Memo

SLP REV. 1 to SLP REV. 2

Date: April 25, 2016 **UBC Gage South** Re:

GAGE SOUTH EXCHANGE PHASE 1 - UNDERGROUND WORKS

Civil Design UTILITIES **NOTES & DETAILS**

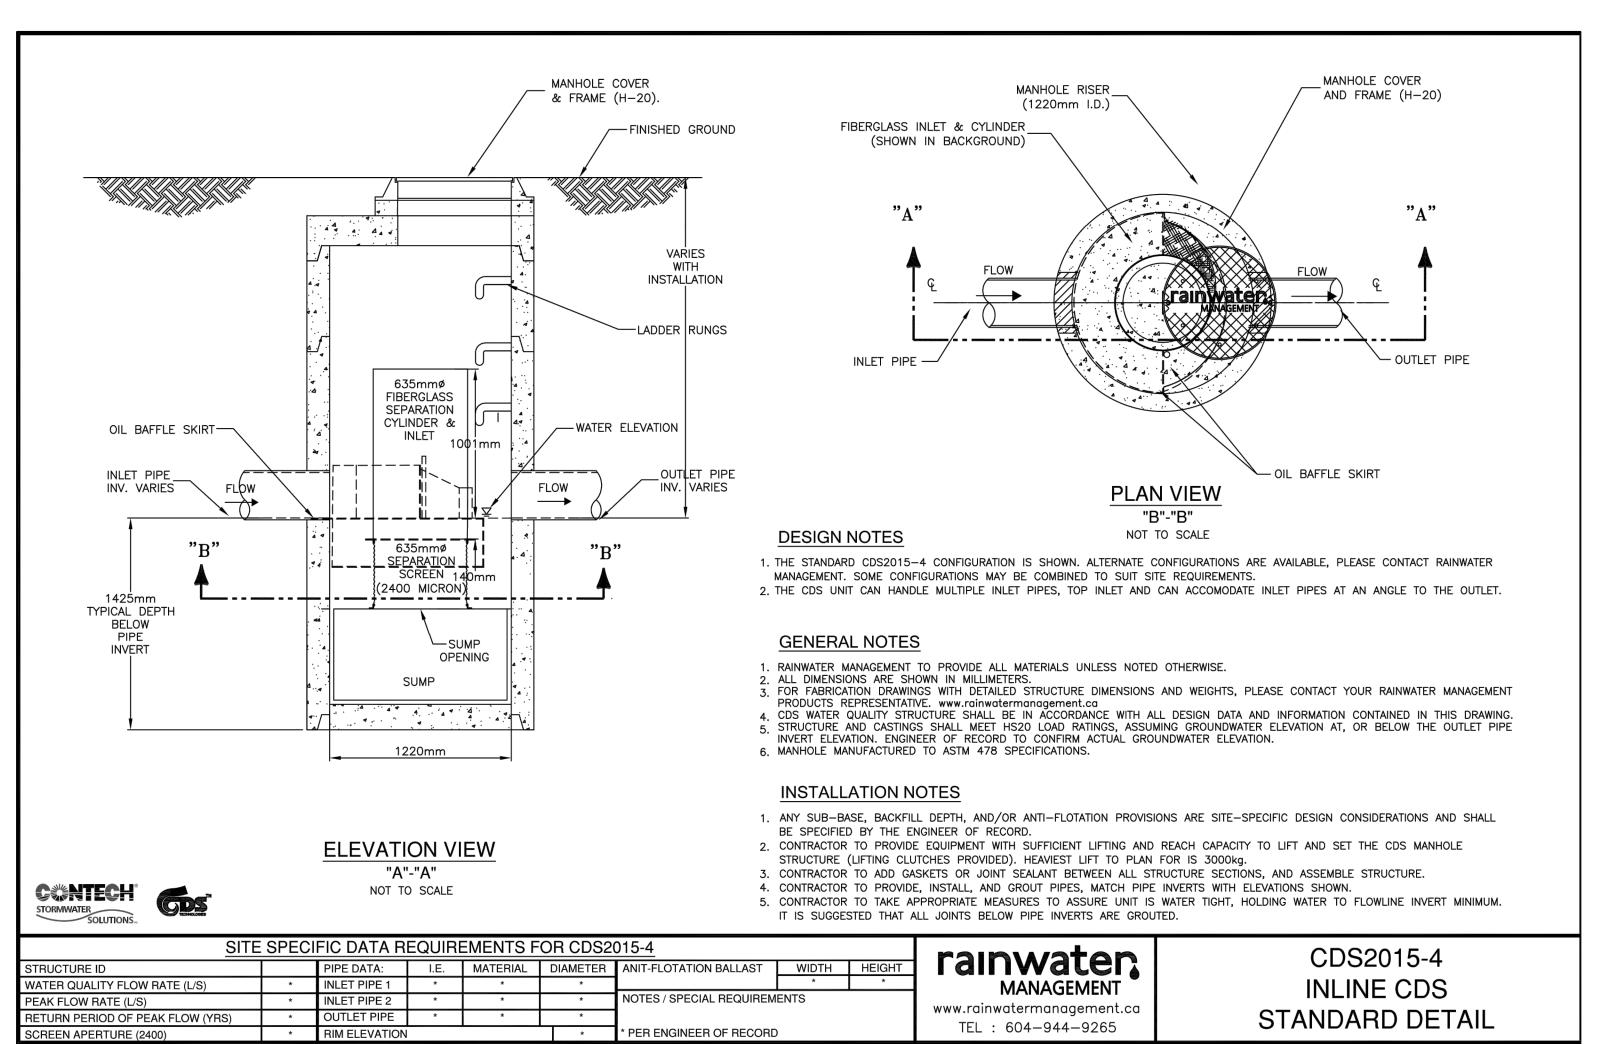
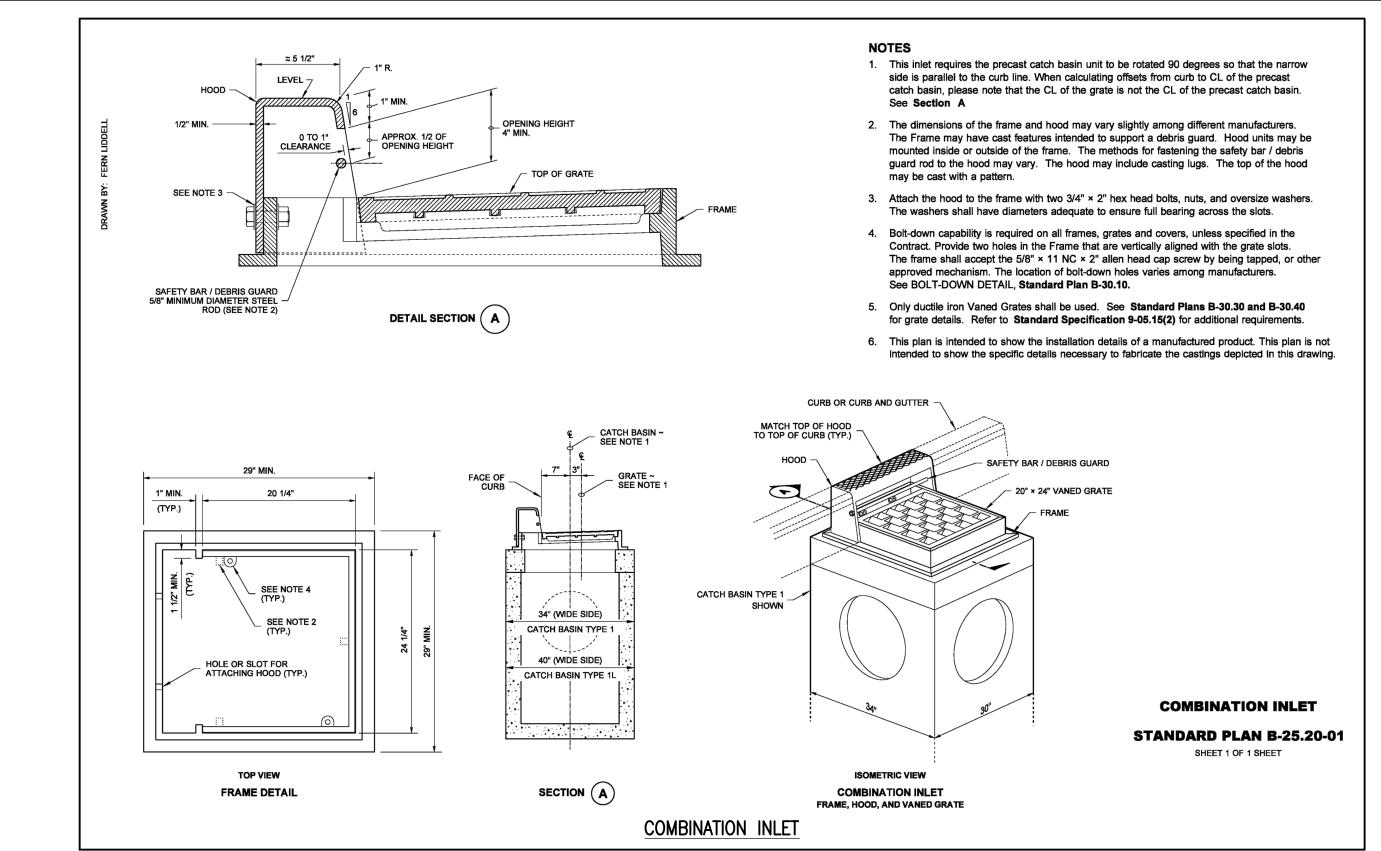
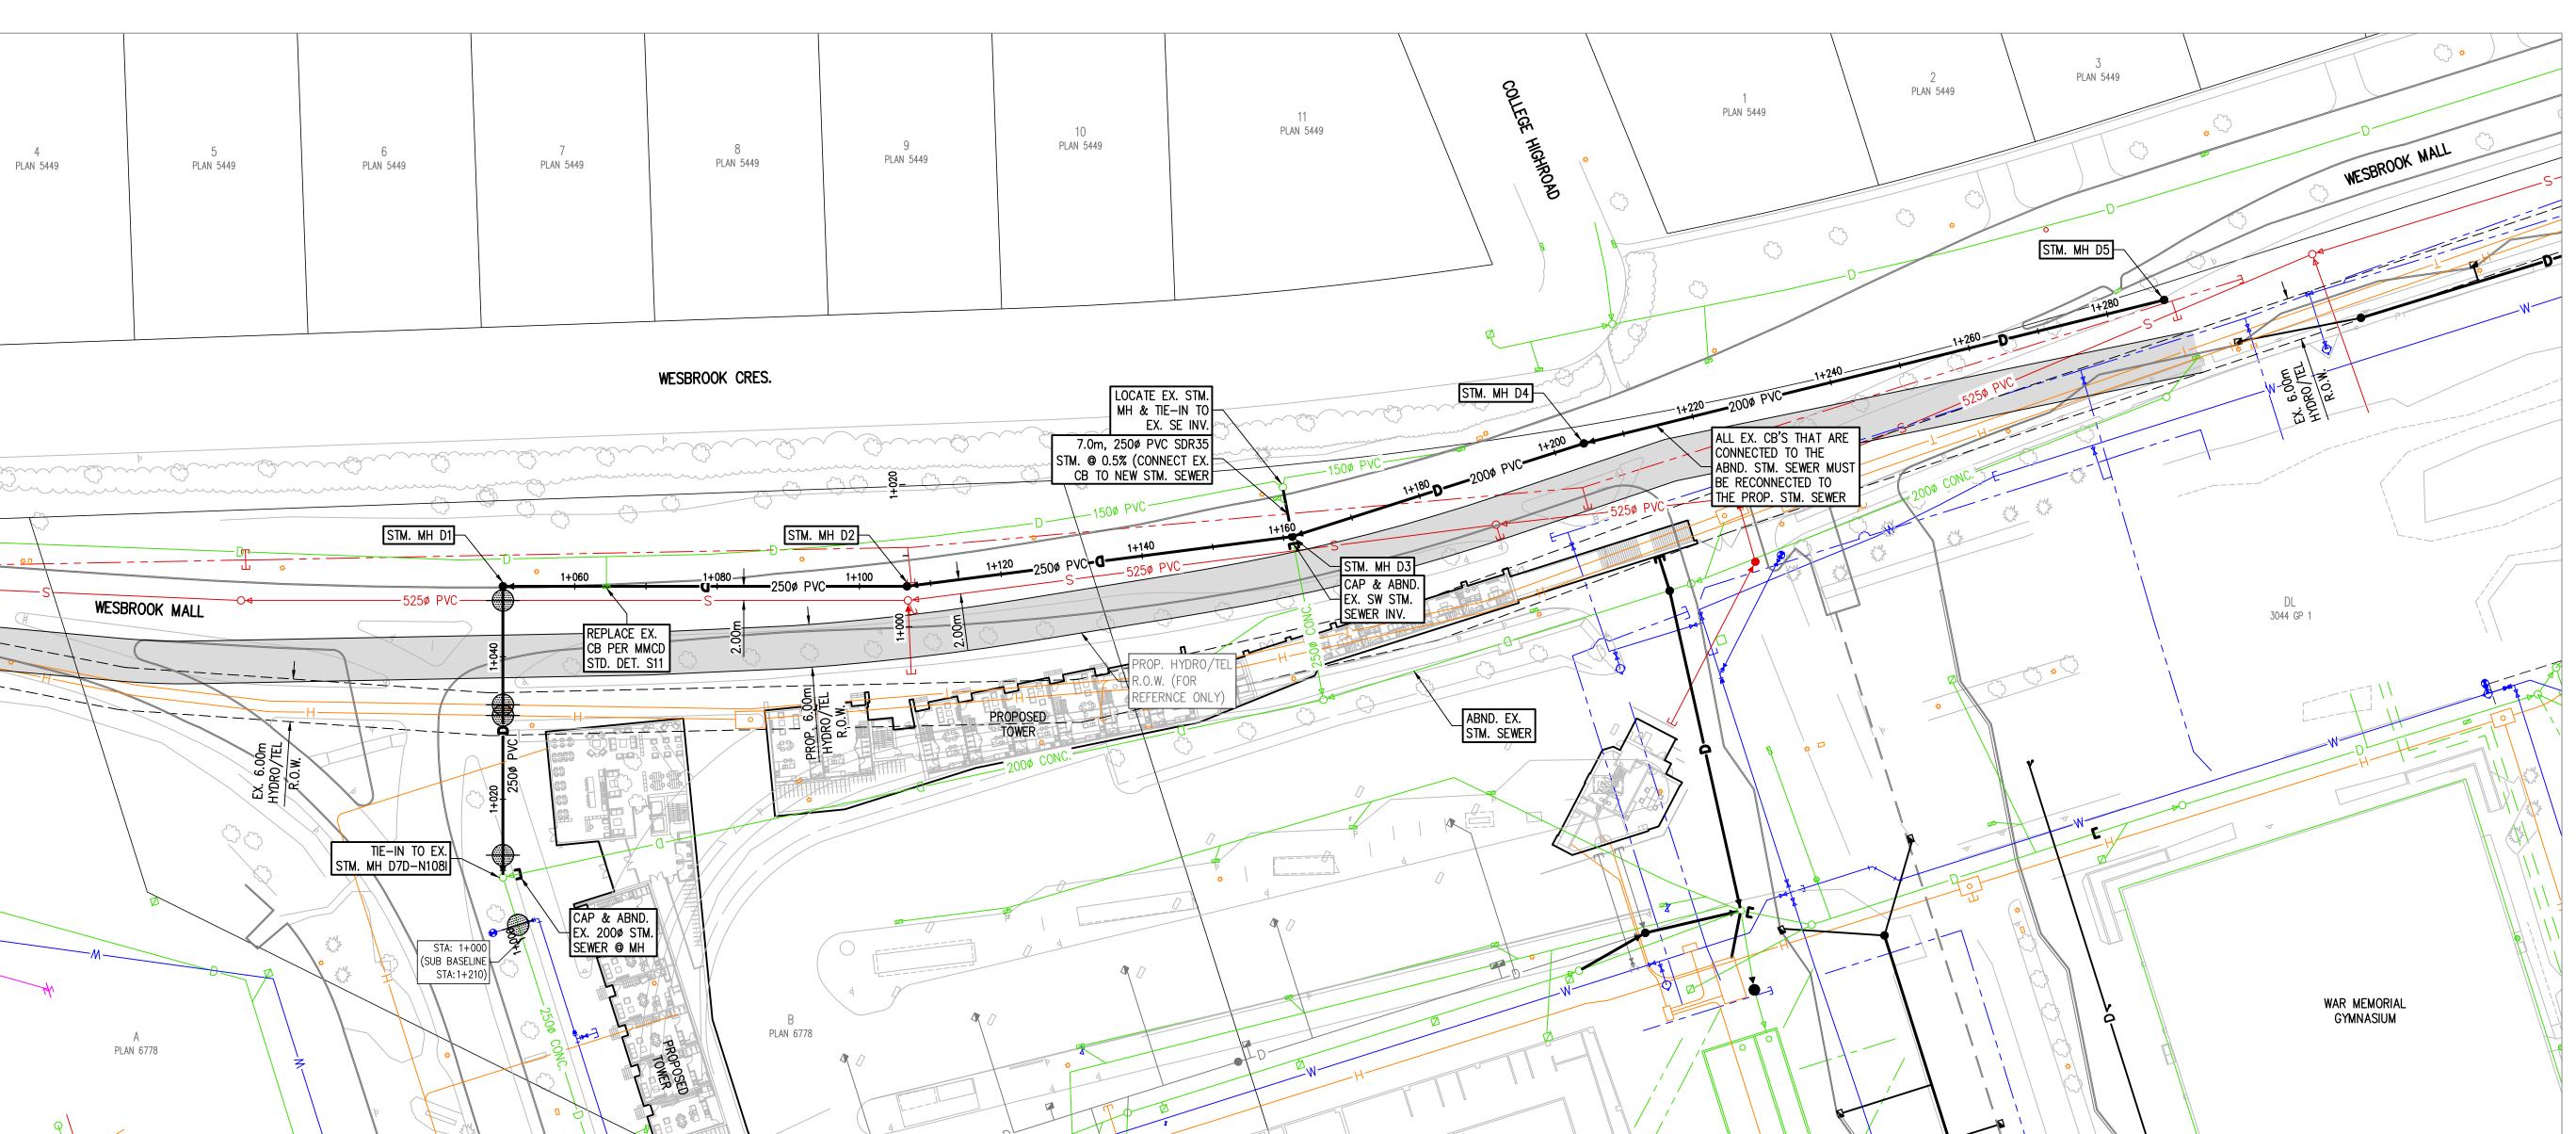
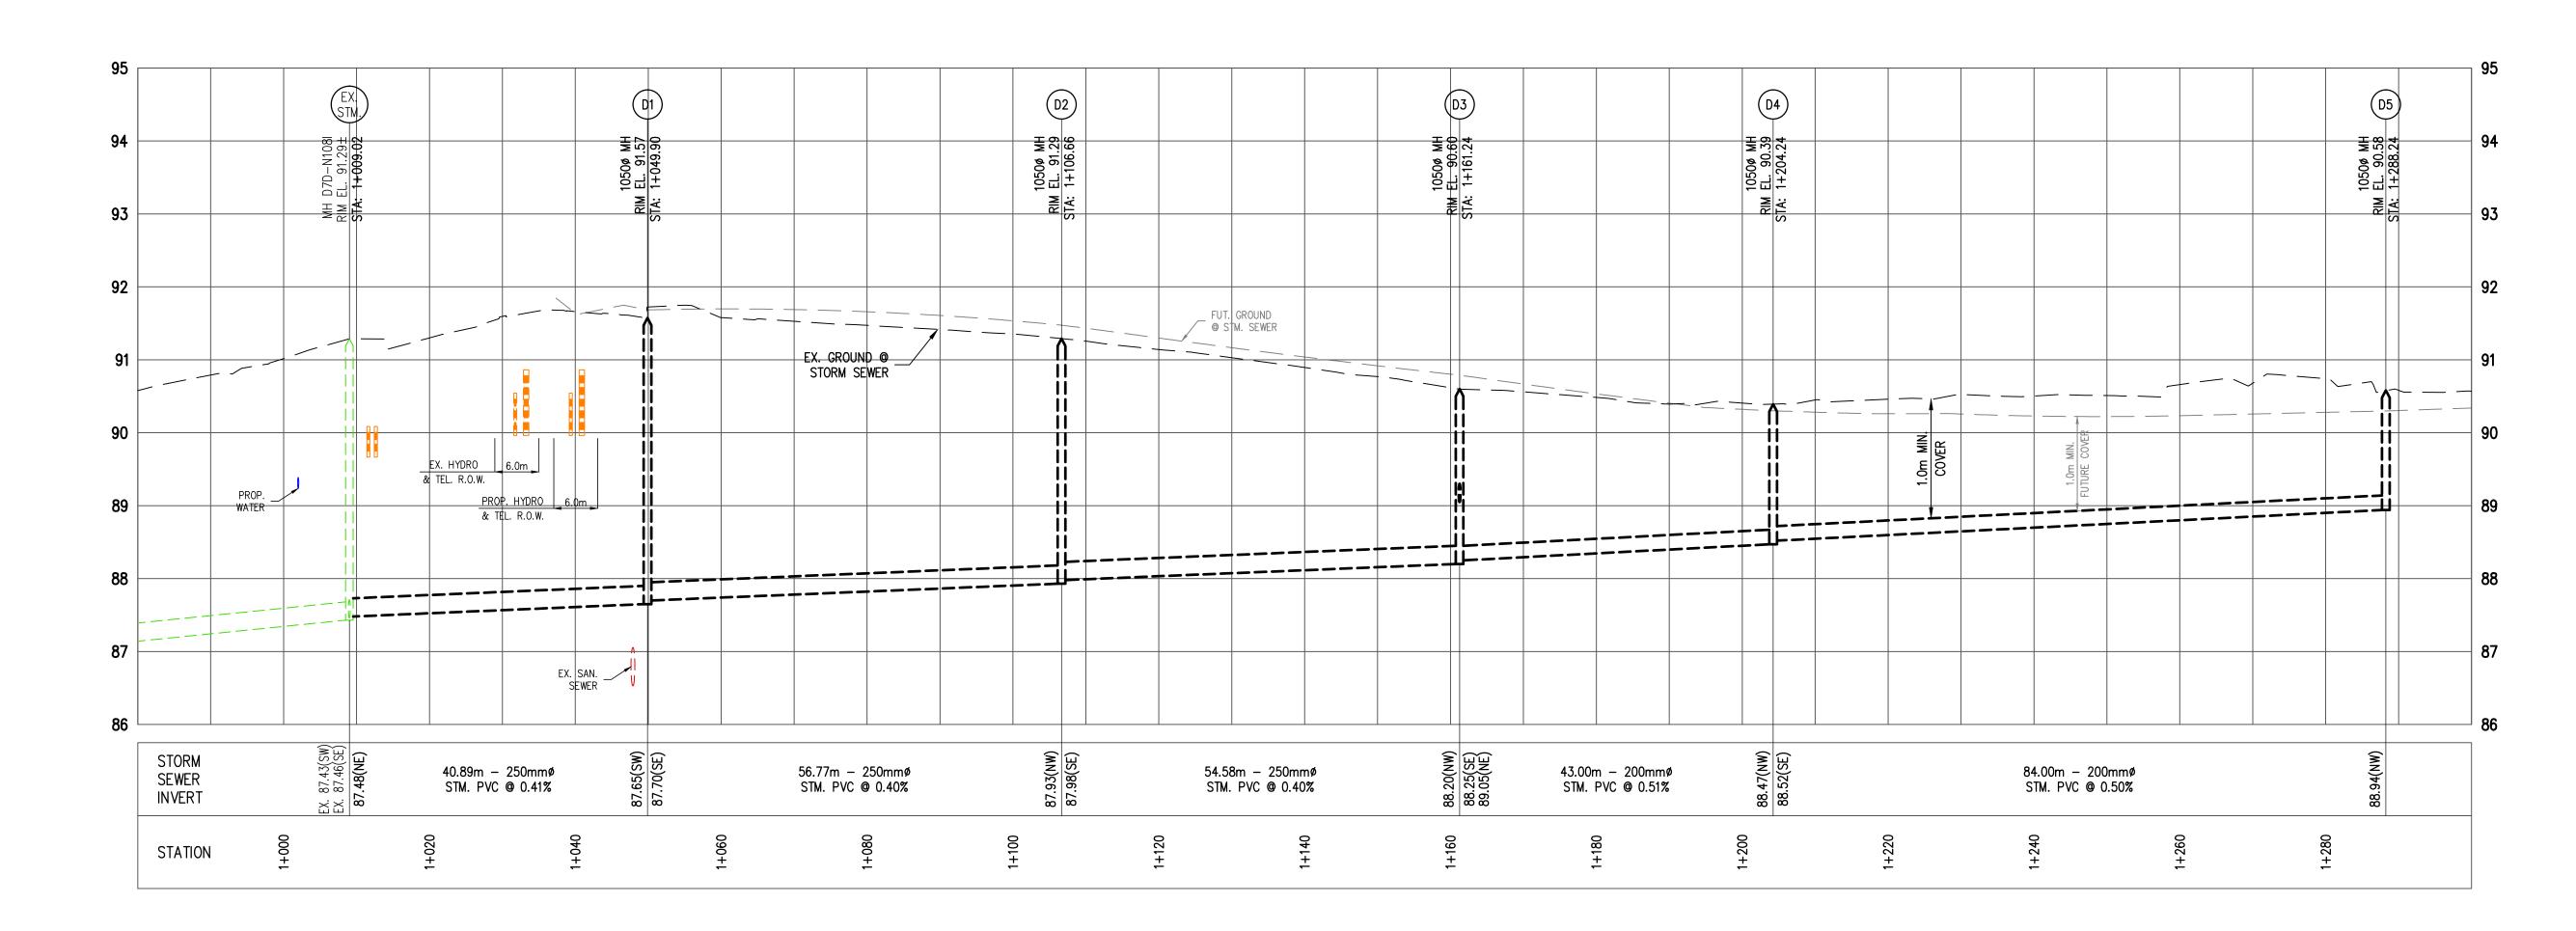
C4E – Utilities, Notes and Details

1) Revised OIL/TSS Removal Manhole Detail added

C 27B

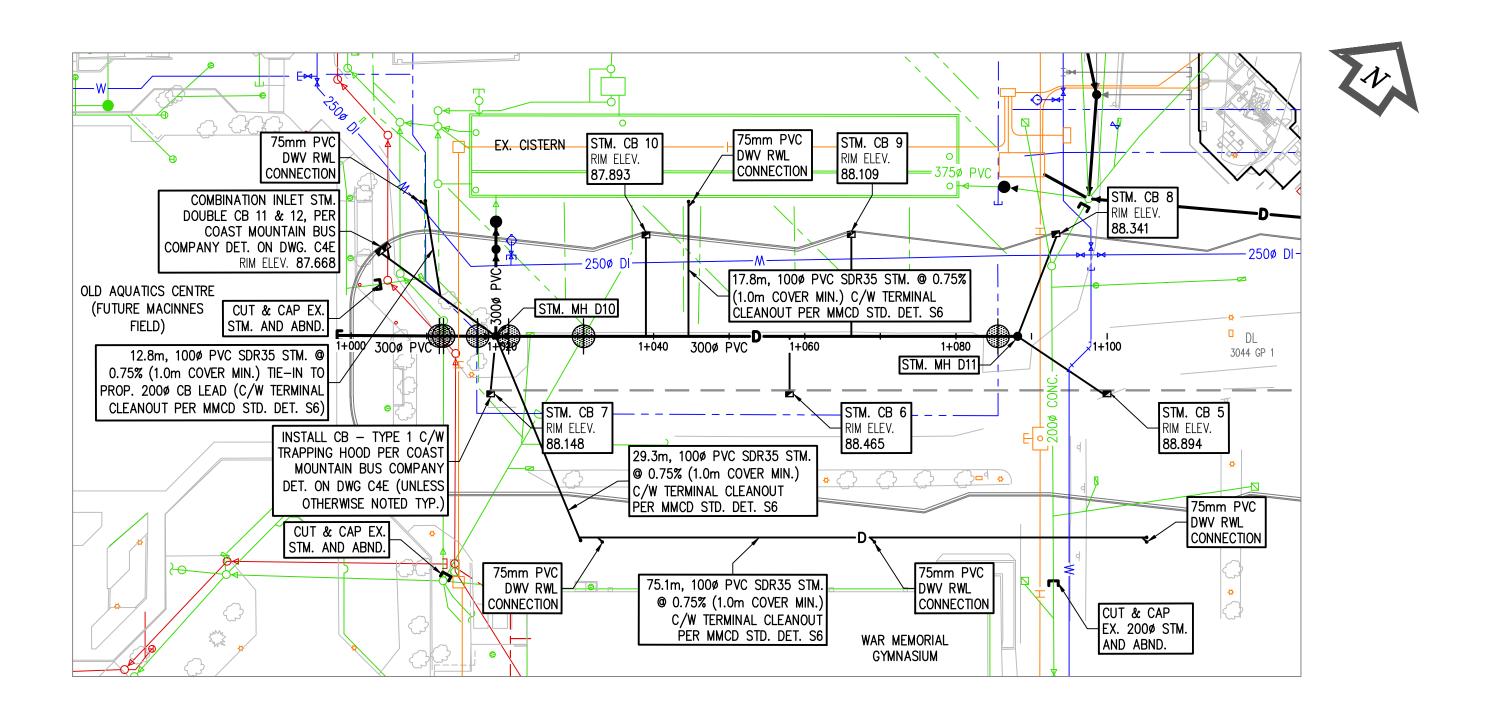
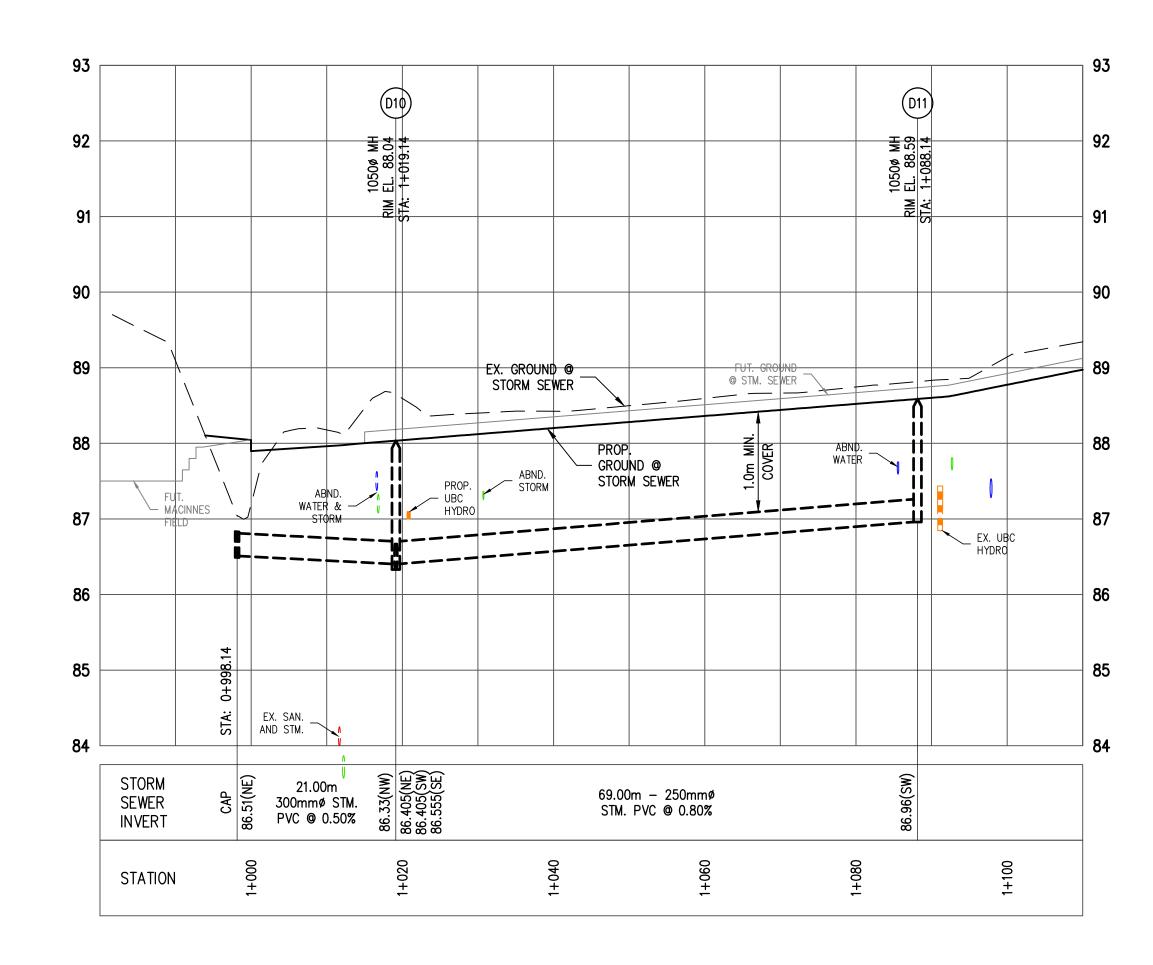
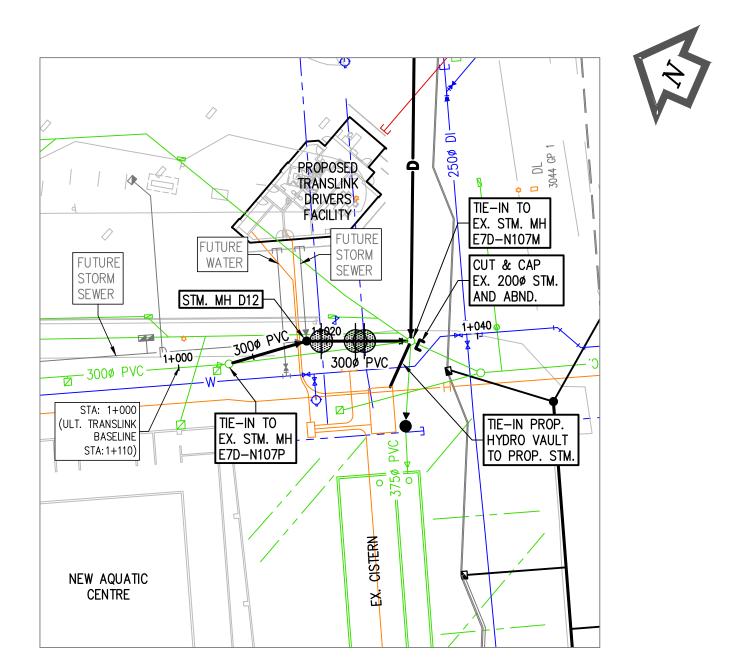
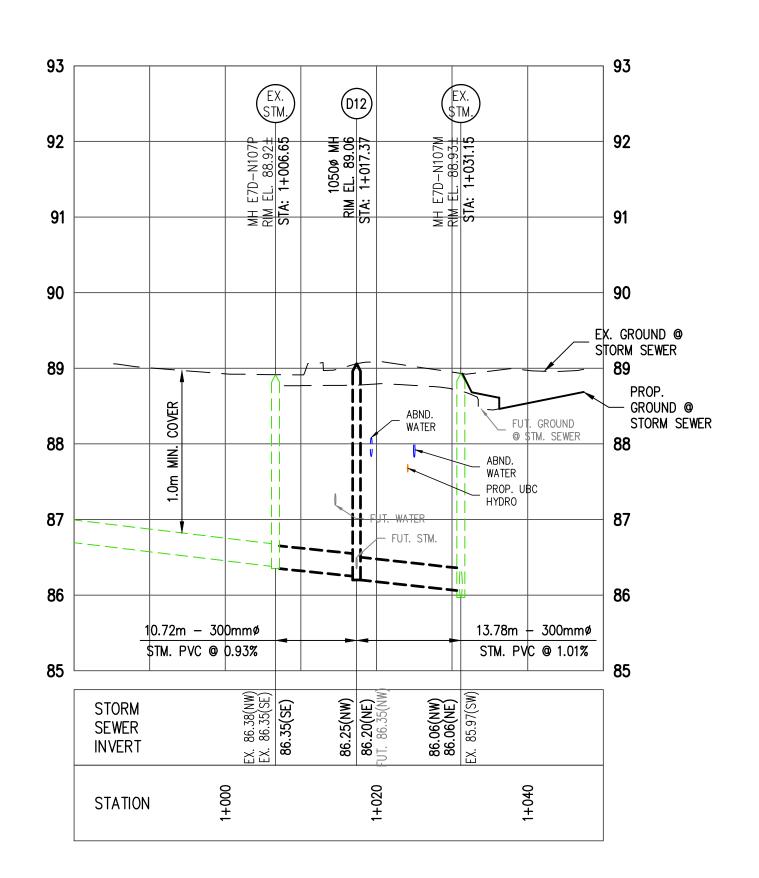
C27B - Utilities, Plan/Profile Phase 1 Storm Sewer

1) Oil/TSS Removal Manhole Revised (Plan/Profile)
